RENESAS TECHNICAL UPDATE

Product Category	MPU/MCU		Document No.	TN-RX*-A0236B/E	Rev.	2.00
Title	RX600 Series, RX700 Series Errata to User's Manual: Hardware Regarding the Realtime Clock (RTC)		Information Category	Technical Notification		
Applicable Product	RX64M Group, RX65N Group, RX651 Group, RX66N Group, RX71M Group, RX72M Group , RX72N Group	Lot No.	Reference Document	User's Manual: Hardware for applicable products (see the table at the last page)		
		All

This document describes corrections to the "Realtime Clock (RTC)" chapter in User's Manual: Hardware for the applicable products.

Figure 32.3 Clock and Count Mode Setting Procedure

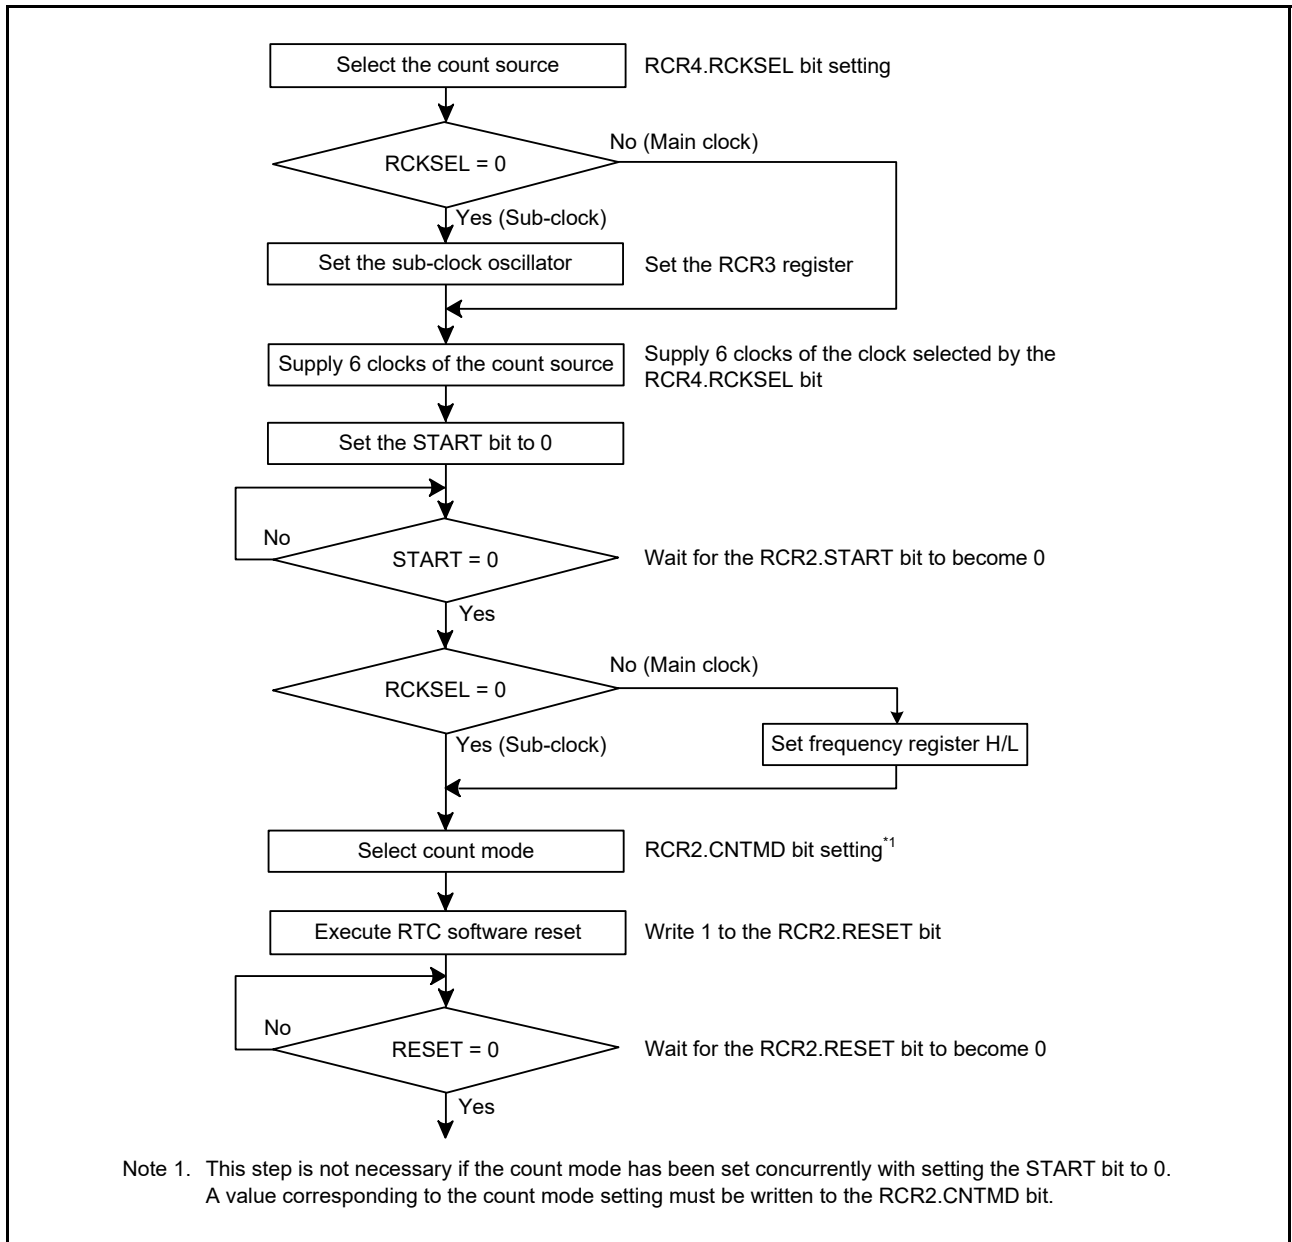
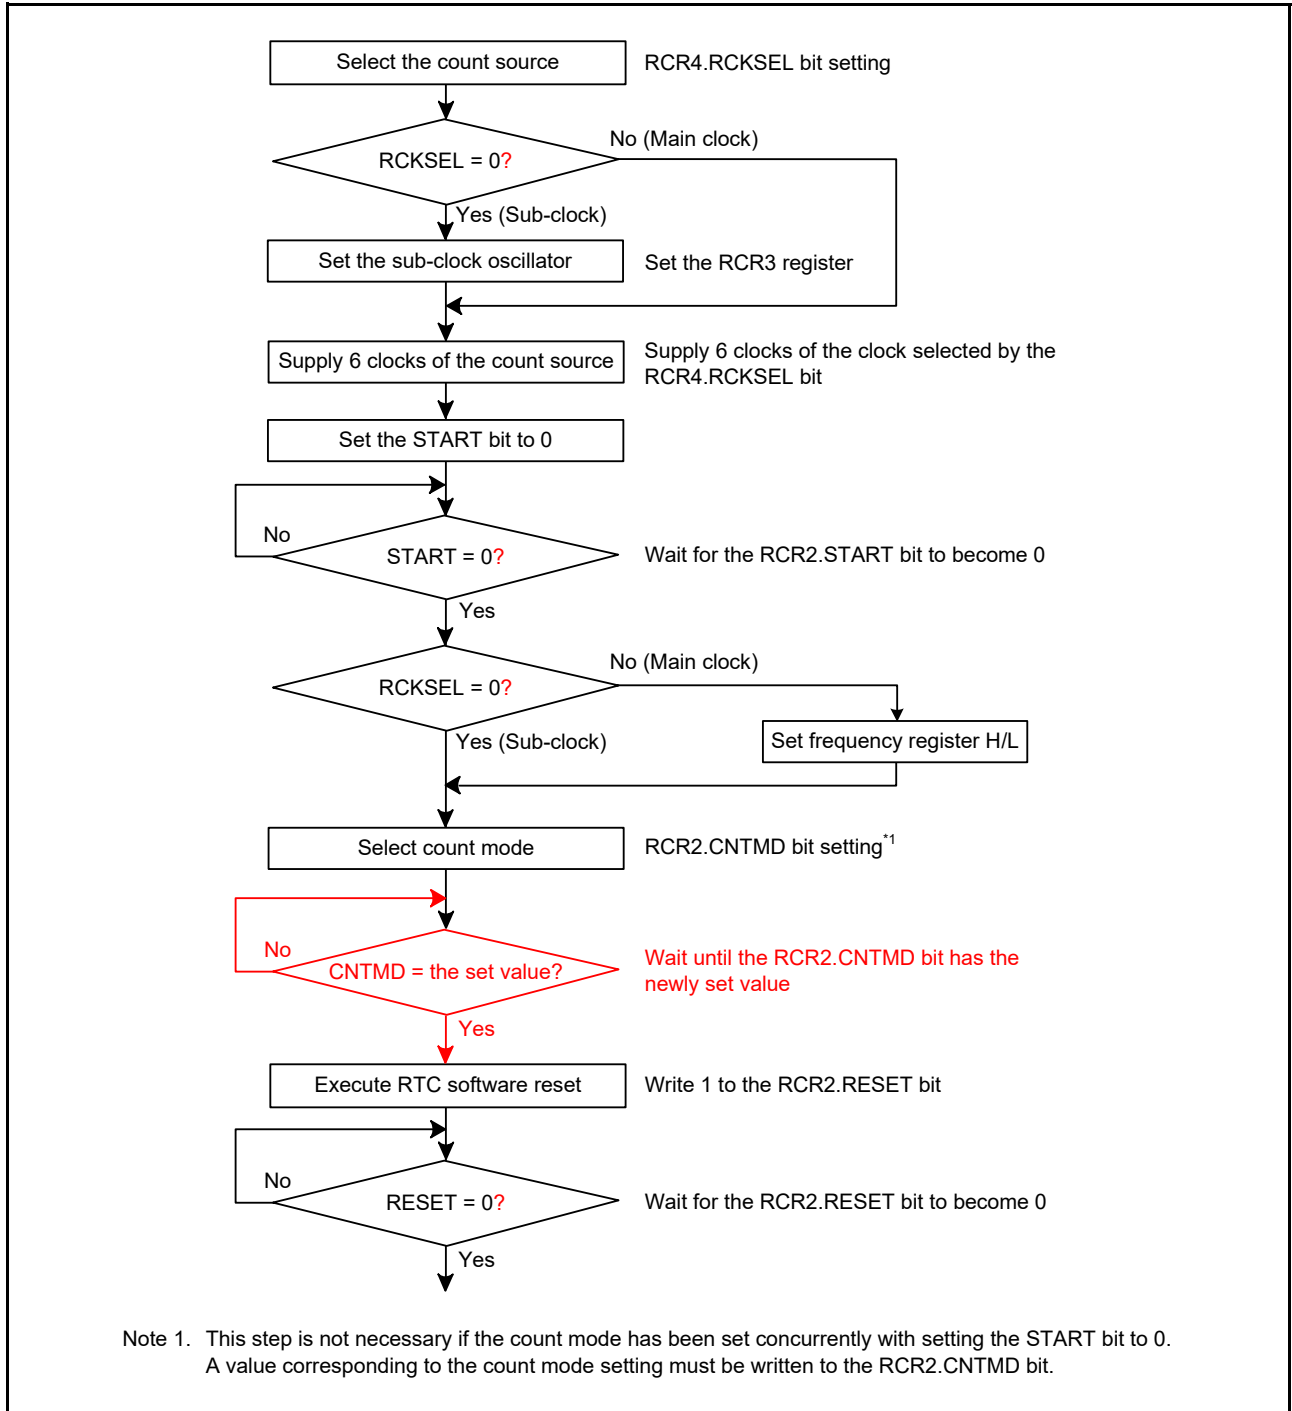
The setting procedure described in Figure 32.3, Clock and Count Mode Setting Procedure is corrected as follows.

Figure 32.14 Initialization Procedure

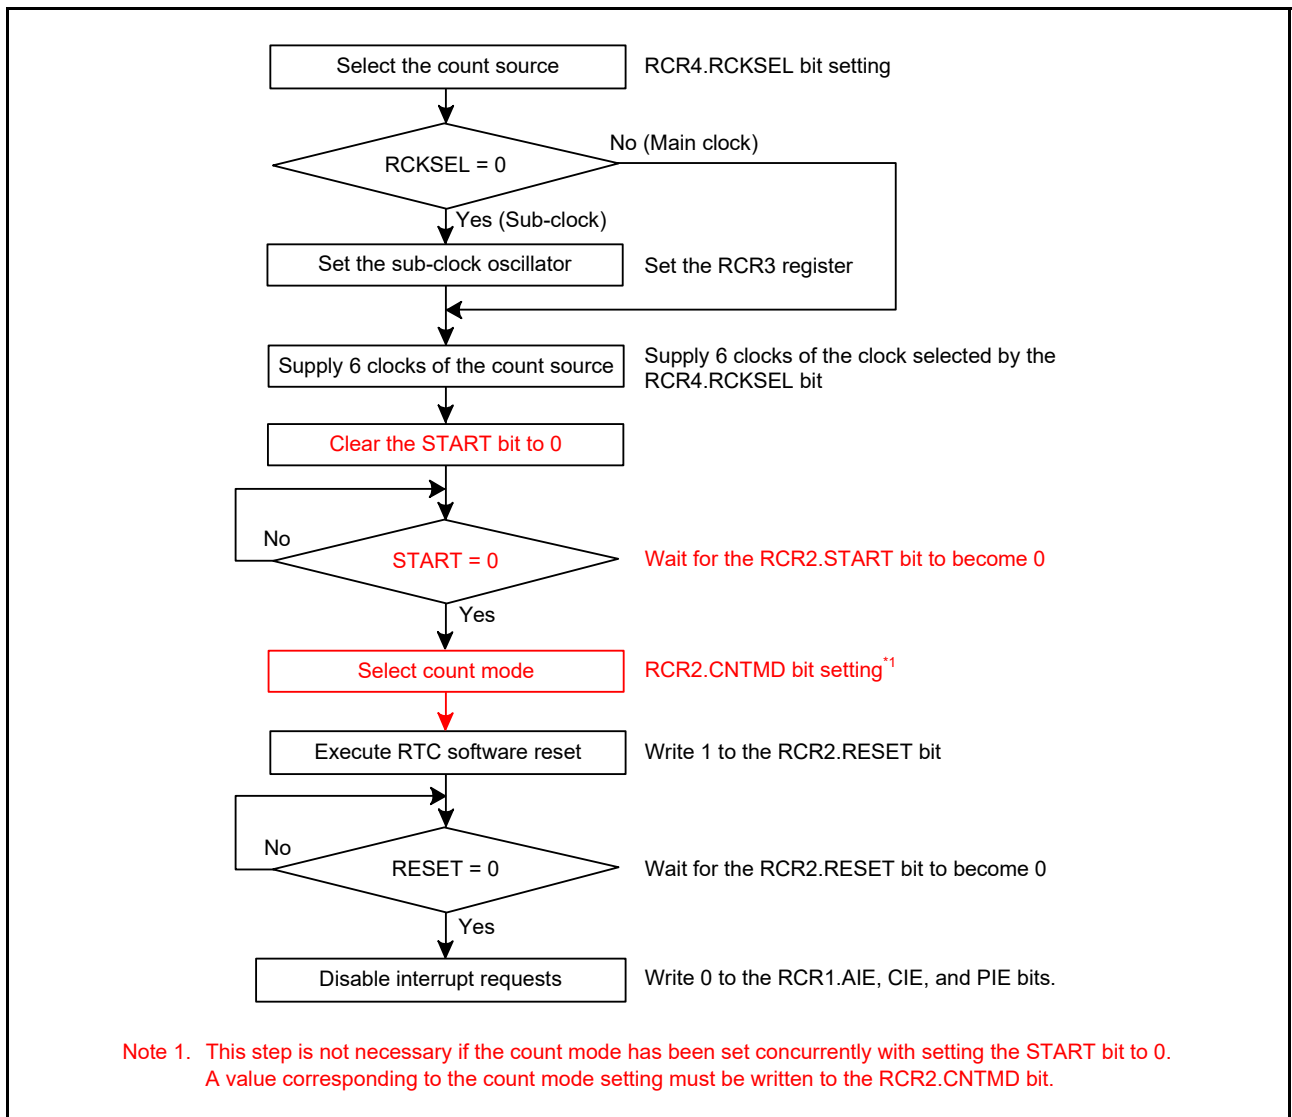
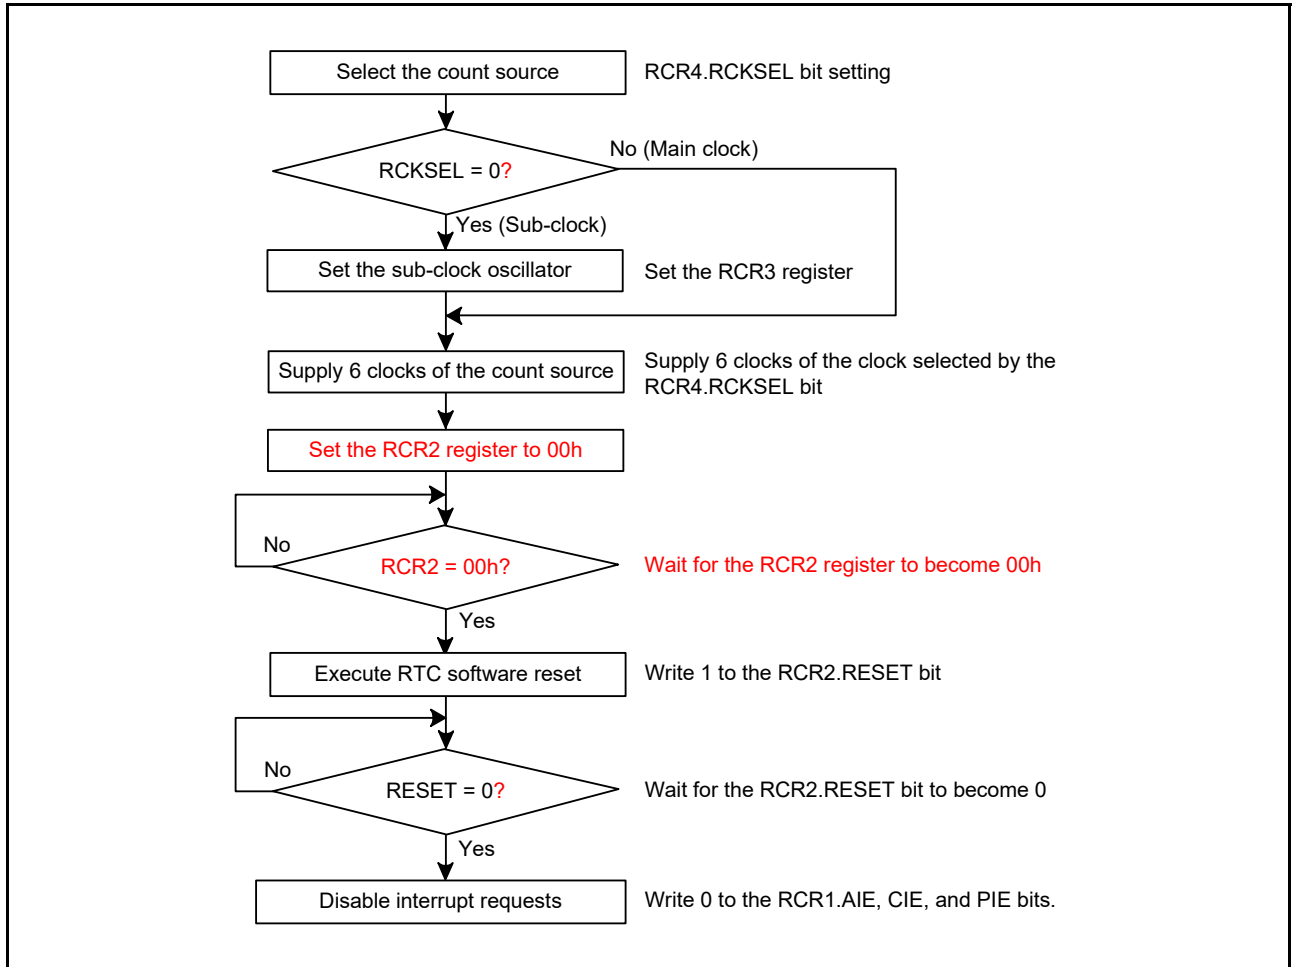
The initialization procedure described in Figure 32.14 of section 32.6.7 Initialization Procedure When the Realtime Clock is Not to be Used is corrected as follows.
